**APPENDIX 4 - FOR INFORMATION
SEVENOAKS - BETHEL ROAD - PARKING PROPOSALS**

SEVENOAKS - Bethel Road

PARKING PROPOSALS FOR BETHEL ROAD, SEVENOAKS

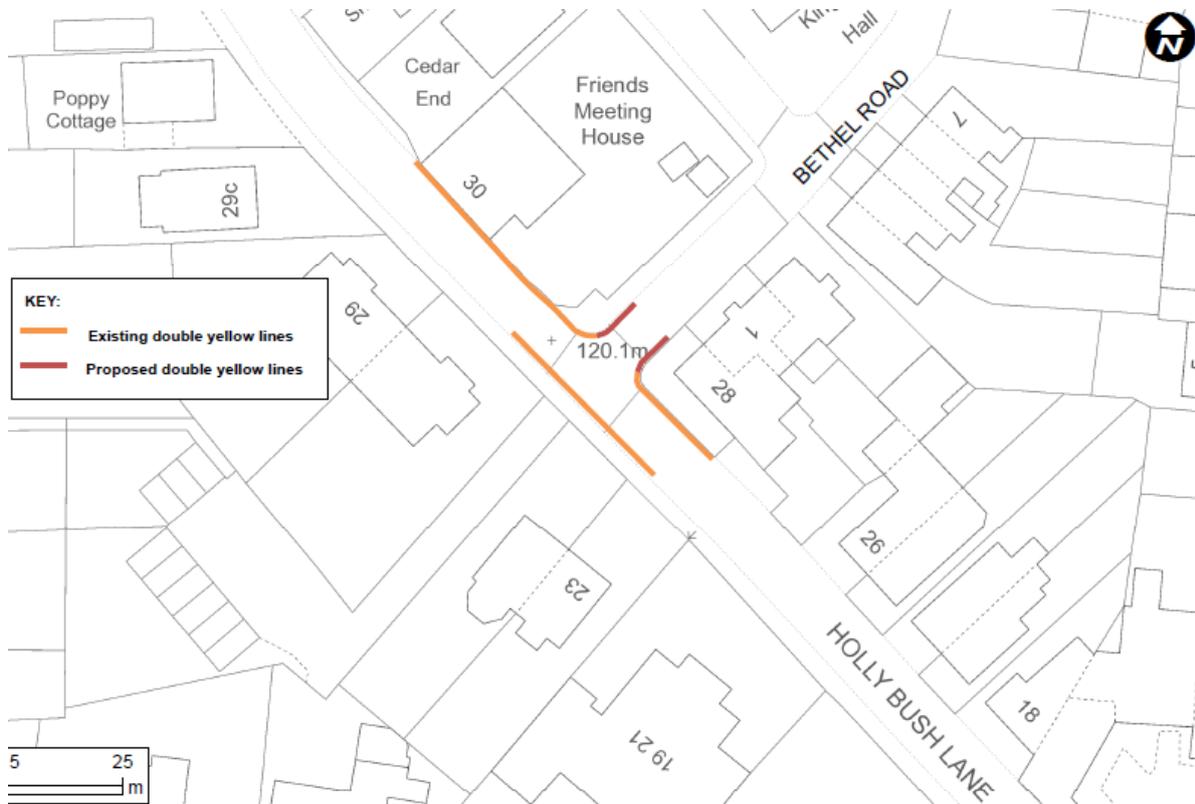
New double yellow line (no waiting at any time) restrictions on both sides, at junction with Holly Bush Lane (adjacent to 28 & 30 Holly Bush Lane).

1. There is huge unfulfilled demand for residents parking in the Hartslands area, so there should never be nett removal of parking spaces. Any removal of any space, as here, must be balanced by the creation of at least two new ones, which is easily possible if SDC holistically looks at the whole Hartslands parking issues rather than following its constant, micro-management, sticking plaster approach. Now the area is a 20mph zone, vehicle speeds are lower so there is less danger posed by on-street parking. An SDC application for double yellow lines in this location has been previously thrown out by residents, so it should not be submitted again by stealth. The main reason why SDC is seeking restrictions in this location is to allow it to send a too large refuse collection lorry down Bethel Road - the obvious solution is to send a smaller lorry, as is done in other roads. Also, pedestrians leaving Bethel Road to cross to the south side of Holly Bush Lane already have a blind junction to negotiate. The ever-presence of a parked car in this location slows vehicles turning into Bethel Road: removal of the parking space will endanger pedestrians and, yet again, have SDC place the

demands of vehicle movement above the needs of pedestrians. Once again, SDC is asked to strike up constructive dialogue with Hartslands' residents about parking needs in the area, and not take a piecemeal, negative approach, as here. Pls contact me to start setting up fully inclusive dialogue meetings with local residents to take a holistic view of parking needs. Whilst this dialogue takes place, this double yellow line application must be refused.

One of the main reasons for the proposal to install parking restrictions in Bethel Road at its junction with Holly Bush Lane is to improve the efficient movement of traffic using the junction, especially large vehicles, such as refuse freighters and fire tenders, by protecting it from parked vehicles. This in turn supports the advice given in Rule 243 of the Highway Code about not parking on junctions.

There is also a dropped kerb on the northwest side of Bethel Road, which is regularly obstructed by parked vehicles, which would be protected by the proposed restrictions.

The proposal will also help to improve road-user visibility and reduce congestion.

In order to minimise the effects on local parking space availability, the proposal is to introduce a very short section of double yellow line restrictions at the junction. The section of Bethel Road concerned is too narrow to accommodate parking on both sides, and as such, the proposal would result in the loss of less than one car parking space, taking into account that vehicles should not be parking in front of the aforementioned dropped kerb.

It is recommended that the objection be set aside, and the proposal be implemented, as drawn.
